CITY OF LA VISTA
MAYOR AND CITY COUNCIL REPORT
OCTOBER 18, 2016 AGENDA

Subject:	Type:	Submitted By:
PUD SITE PLAN APPROVAL — LOT 9, SOUTHPORT EAST REPLAT SIX (NE OF SOUTHPORT PKWY & GILES RD)	◆RESOLUTION ORDINANCE RECEIVE/FILE	ANN BIRCH COMMUNITY DEVELOPMENT DIRECTOR

CASE NUMBER: 2016-PUD-05

RE: PUD Site Plan - Initial Review
Lot 9, Southport East Replat Six

SOUTHPORT EAST REPLAT SIX PLANNED UNIT DEVELOPMENT LANDSCAPE PLAN	
Drawn By:	MT
Scale:	1"=30'
Sheet:	4 of 4
Matthew T. Tietz 10/29/2013 7:27 AM K:\Desktop\2000\0319\000000000000.dwg

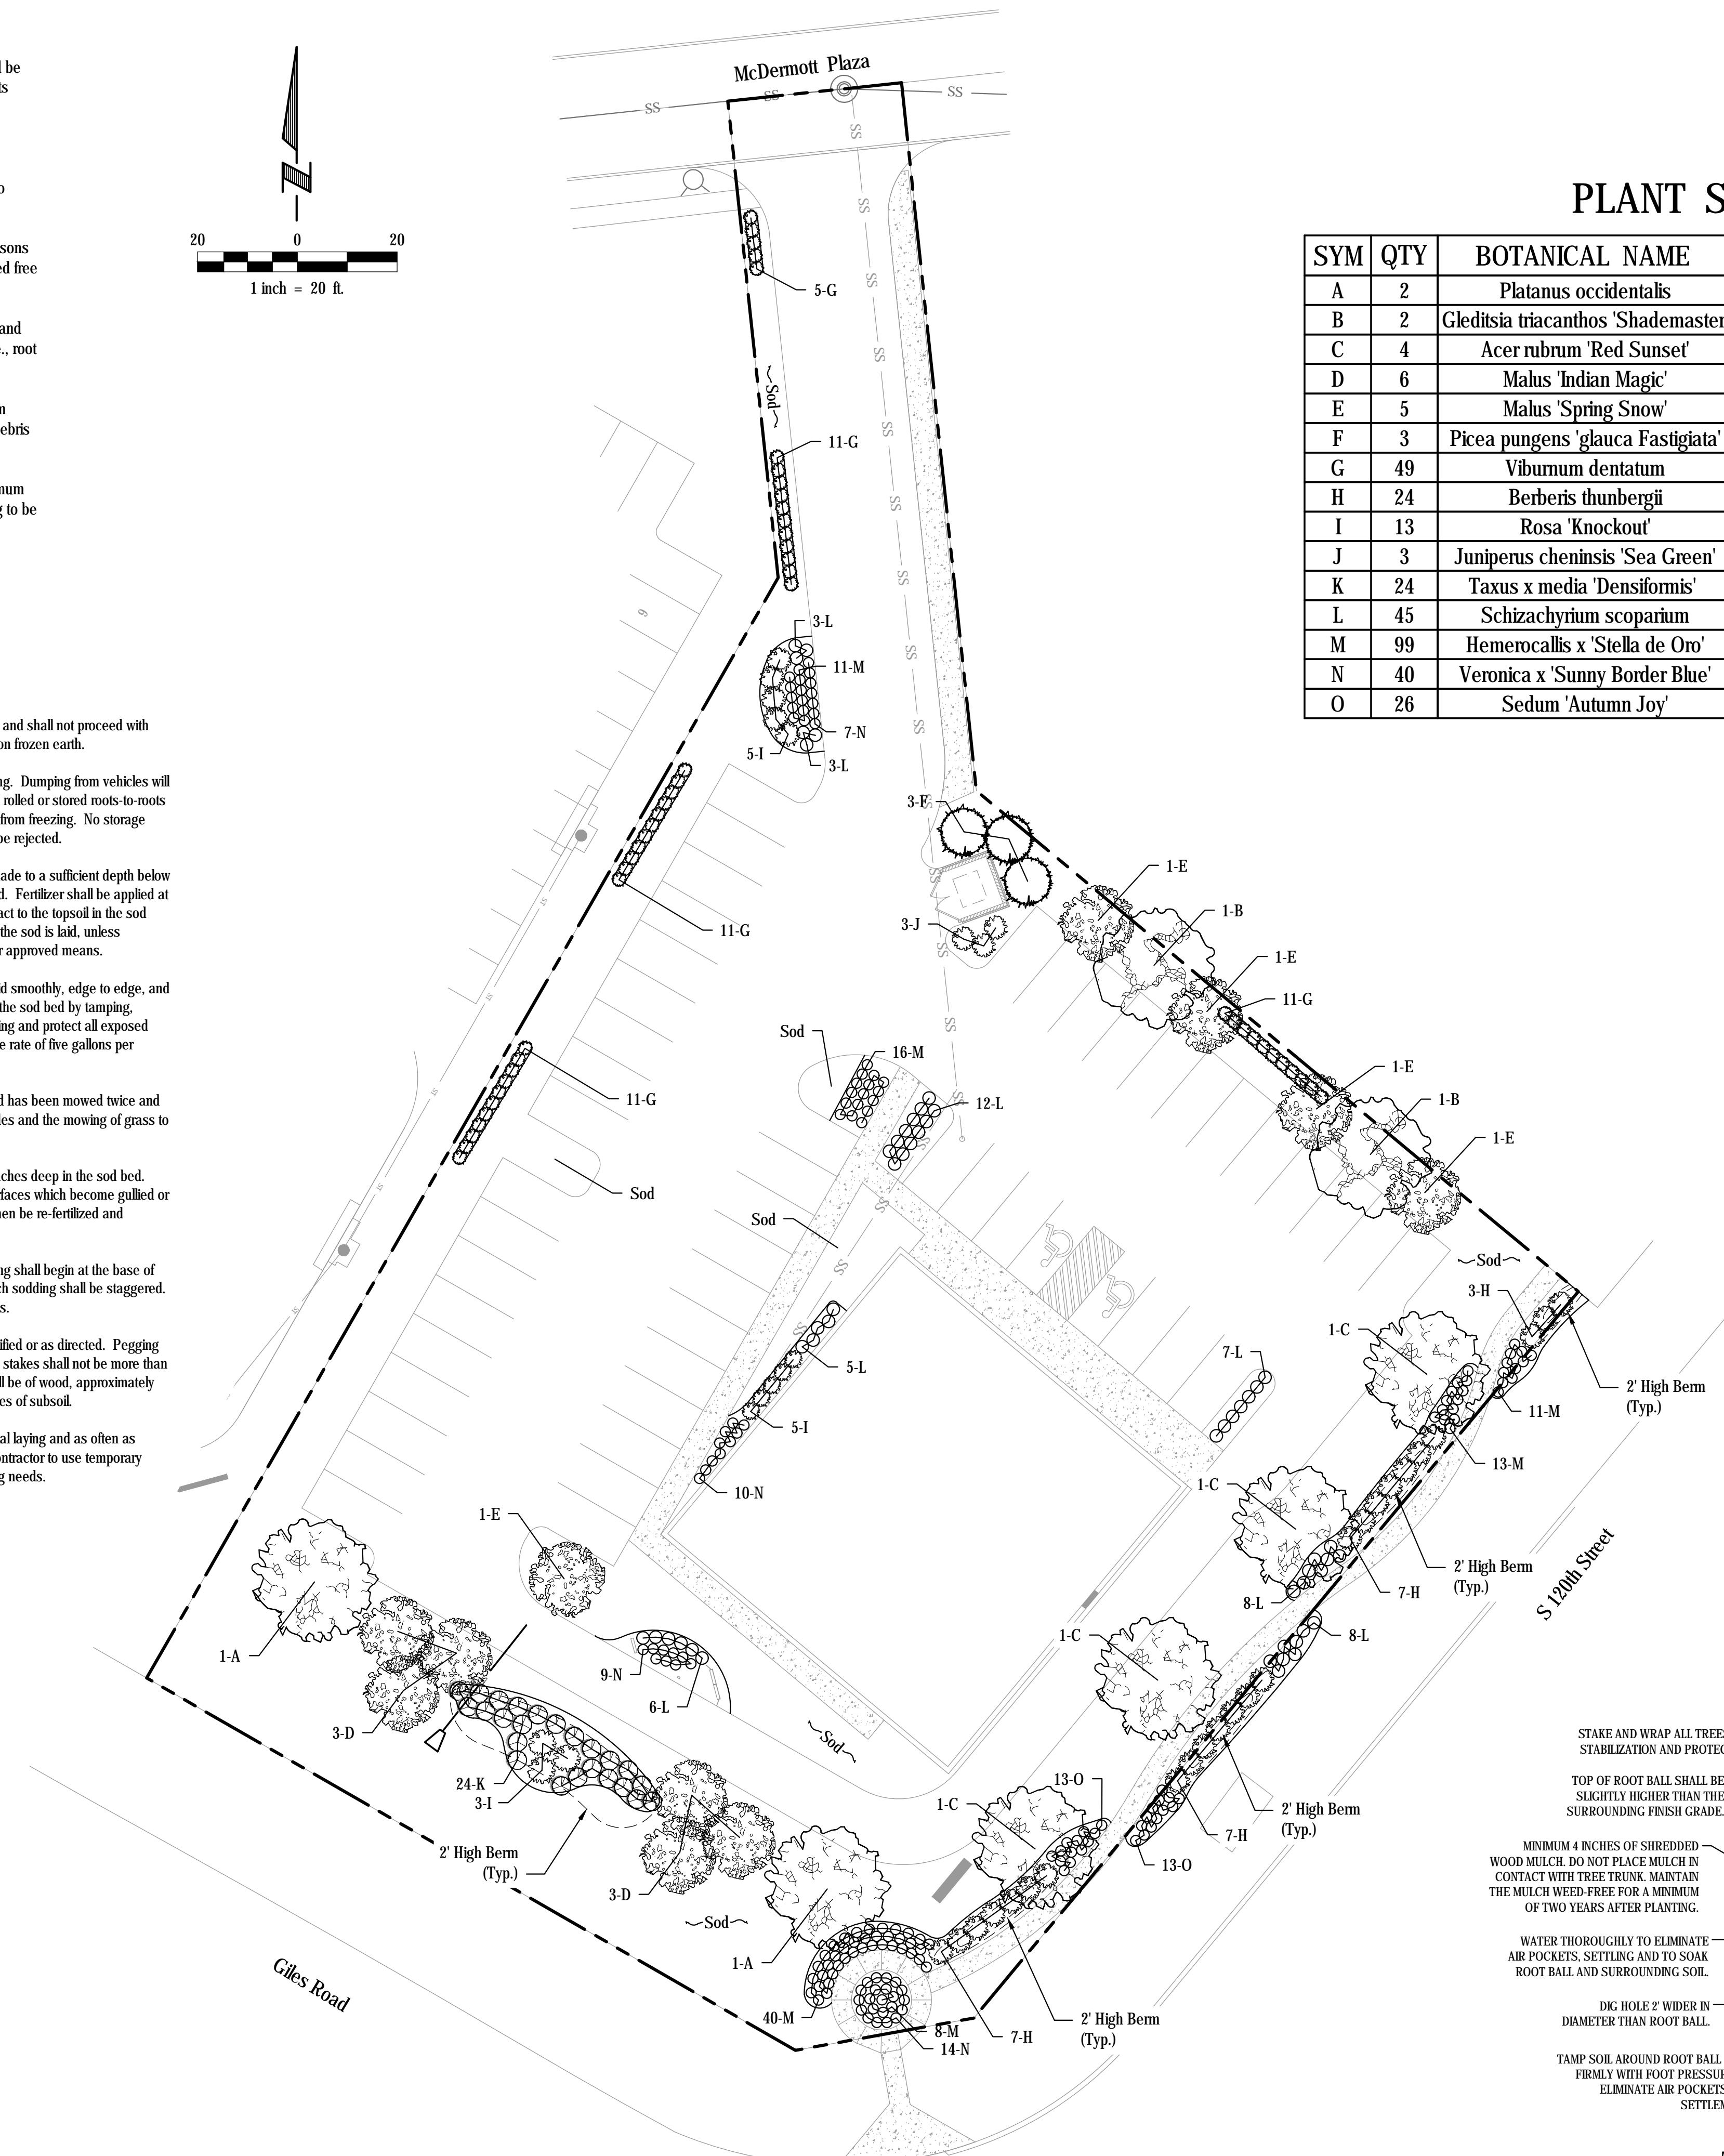
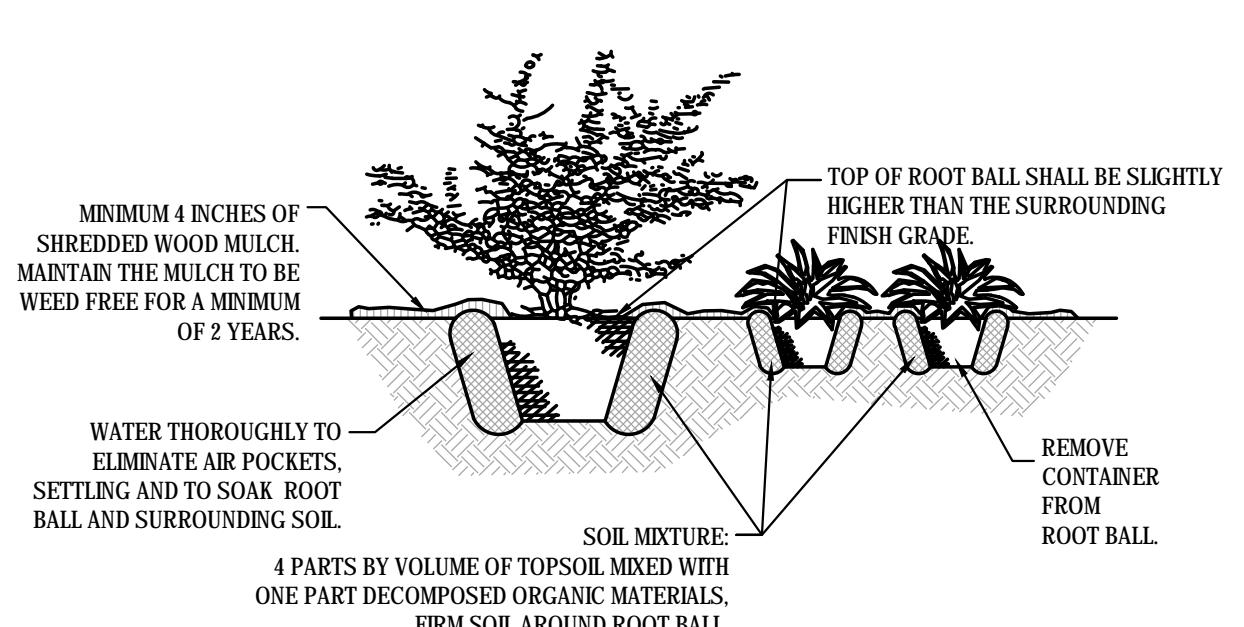
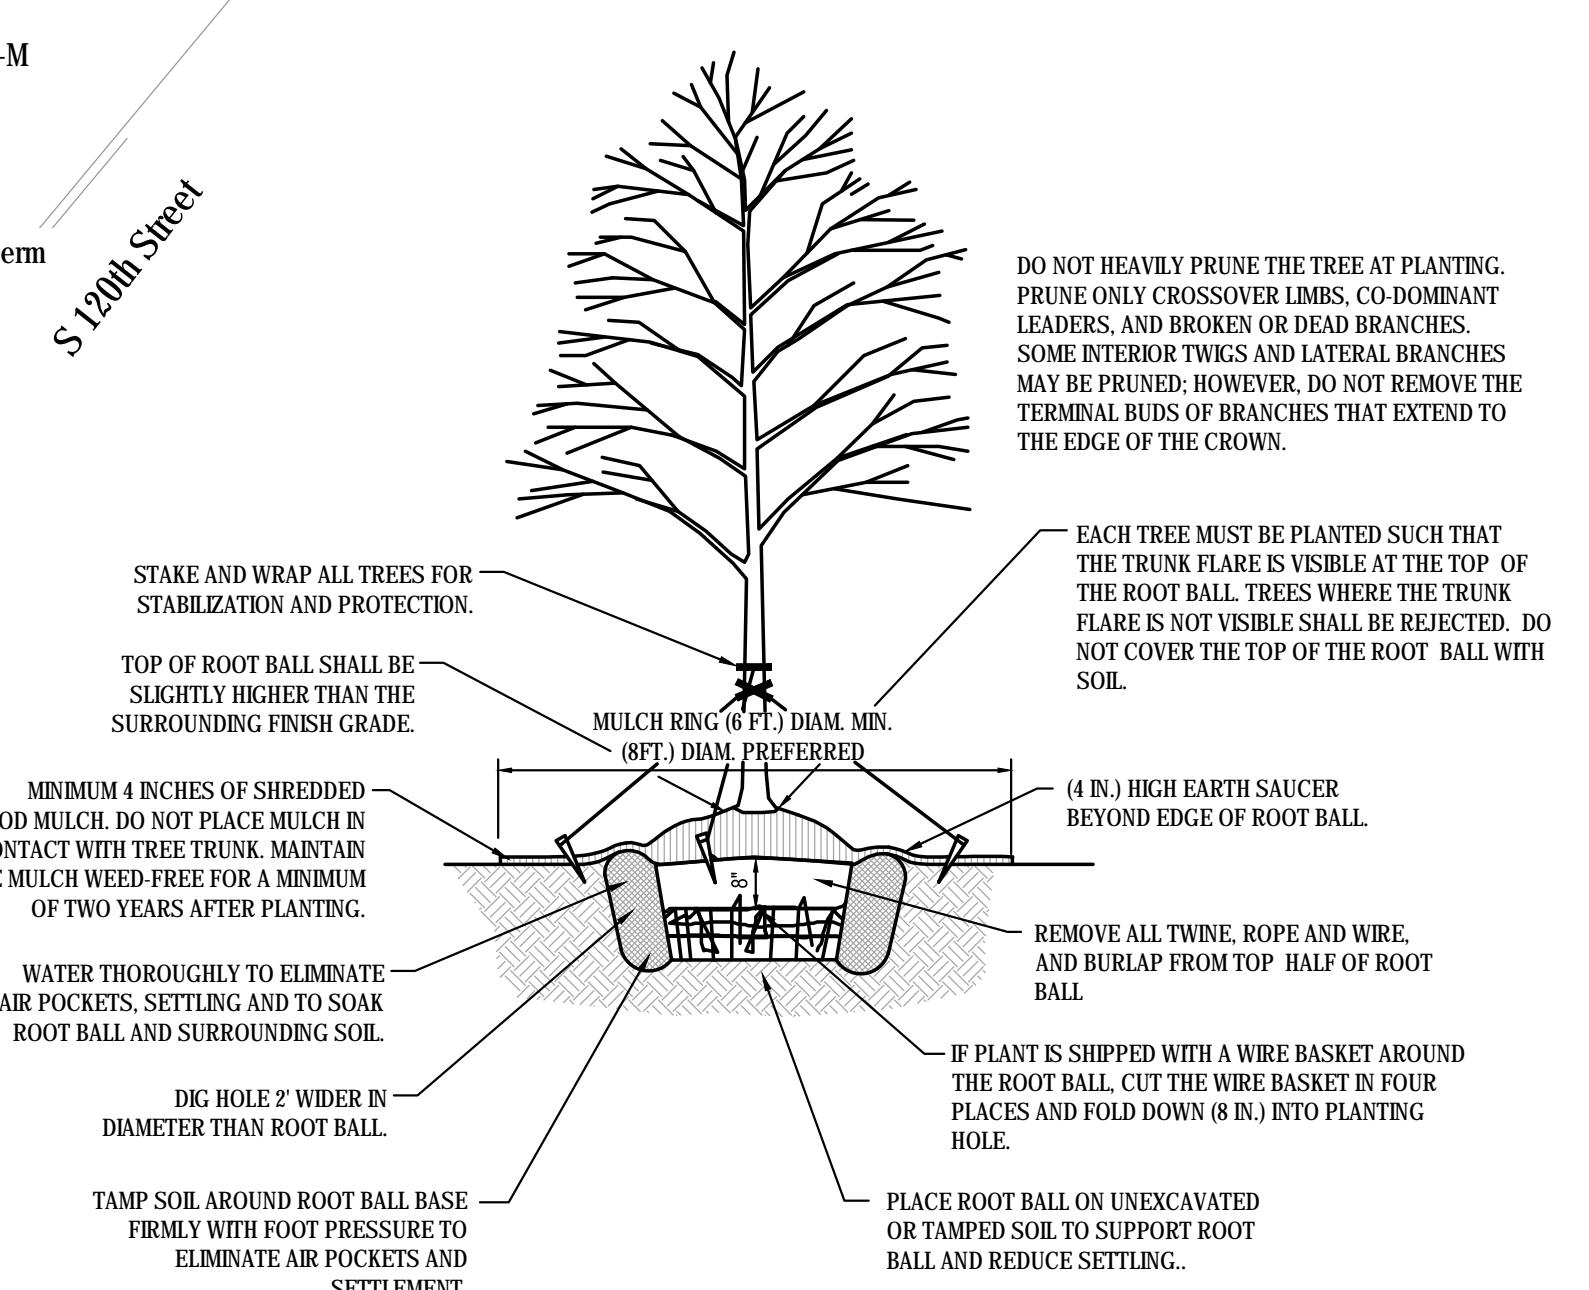
2. Planting Schedule, approximately half of the proposed selections are non-compliant. Refer again to Appendix F and G. for approved Street Tree and Plant Lists.

3. No spacing dimensions are indicated on any of the plantings. The spacing appears graphically to comply with the Guidelines but only by approximately referencing the graphic scale. Refer again to Appendix B & C for required streetscape planning concepts.

4. The new proposed landscape groupings on the east property do not appear to take in to account the existing plantings previously installed by Runza. The proposed groupings should be adjusted to fill the gaps between Runza's groupings and give adequate distance between existing and new trees. Refer to the existing conditions aerial image below demonstrating how Runza and Burger King handled their adjacent groupings to provide a continuous screened condition, and also highlighting the potential current gaps along the referenced east property line.

- a. Plant Schedule - Please refer again to the Southport Guidelines, Appendix F and G. for approved Street Tree and Plant Lists. The majority of the proposed selections are non-compliant. Note that we have recently interpreted the Guidelines to allow grasses, even though not included in the required Plant List, to be consistent with what has been previously installed in both Southport East and West. We will allow Sunset Red Maples along Eastport Parkway (old 120th Street) whereas the guidelines call for an Autumn Purple Ash. American National Bank, directly to the southeast, utilized Maples as well so they would match.

- b. The Guidelines don't include Colorado Blue Spruce, although there are existing conifers on the Runza and Burger King sites adjacent to Lot #9. We will allow the spruces because they are screening the view of the trash enclosure from McDermott Plaza, which is desirable.

- c. Plant sizes meet or exceed the minimums. The Sea Green Juniper is 2 gallons to small. The Dense Yew is using a different measurement than the Guidelines (3 Gal v. 18"-24"), which may be similar in size, but needs to be verified.

- d. Please review and resubmit the Landscape Plan with revised selections and designations.

1. Comments #1-4 - Plant schedule has been revised to be compliant with Southport East Design Guidelines. Landscape groupings have been revised to coordinate and fill in the gaps of existing plantings previously installed by Runza.
2. Comment #2 - We understand that prior to submission for a building permit, an application for design review approval, through the Southport East Design Guidelines, will need to be submitted.
3. Comment #3 - We understand all light fixtures will need to meet the requirements of the Southport East Design Guidelines.
4. Comment #4 – We understand the design of the monument sign will need to comply with Section 7.01 of the Zoning Ordinance and the Southport East Design Guidelines.

1. Comments #1 – 2 – We have addressed the comments from the City's third-party architect and revised the Landscape Plan. We understand that Design review approval, through the Southport East Design Guidelines, will need to be achieved before building permit submittal.
